IMPORTANT SAFETY RECALL – SN602

Safety Recall Notice 13V-089

SN-602-13

SUBJECT: *Machinery Bushing 83725*

Inspect here on lift cylinder

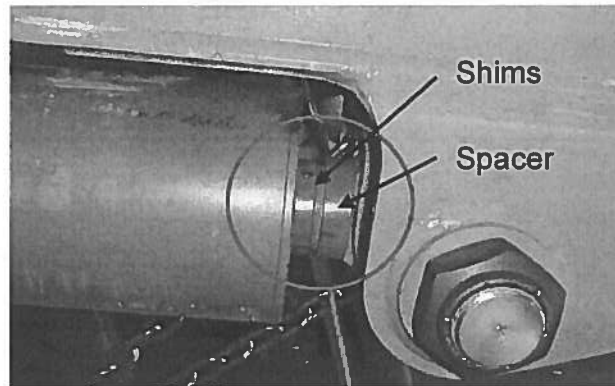
Terex Utilities has discovered that the metal shim, p/n 83725, used on the XL4000 series Digger Derrick lift cylinder has been supplied with the wrong material. The shim material is too soft and will compress with load which may result in fatigue in the threads of the rod eye. **If the rod eye threads fail the rod eye may separate from the cylinder and allow the cylinder and boom to fall.**

All XL4000 units require replacing the existing shims and spacer with one hardened spacer. Immediately inspect the preload on the cylinder rod to eye junction to determine if the shims are loose.

1. If the shim does not move when the boom is in the stored position you can continue to use the machine if you check the shim daily. Contact your nearest Terex Utilities dealer or Terex Utilities to arrange repairs within 60 days of receipt of this bulletin.
2. If the shims are loose and can be moved with the boom in the rest, you can continue to use the unit until repairs can be performed if the rod to eye is torqued to 500 ft-lbs and inspected daily until repaired. Schedule repairs within 30 days with Terex Utilities.
 - Procedure to tighten rod eye: Loosen the set screws on the rod then tighten the rod eye by turning the rod. You do not need to un-pin the cylinder. Tighten the rod eye to 500 ft-lbs and retighten the set screws to 15 ft-lbs. Inspect the shims for looseness daily. If they loosen again take the unit out of service and contact TEREX Utilities
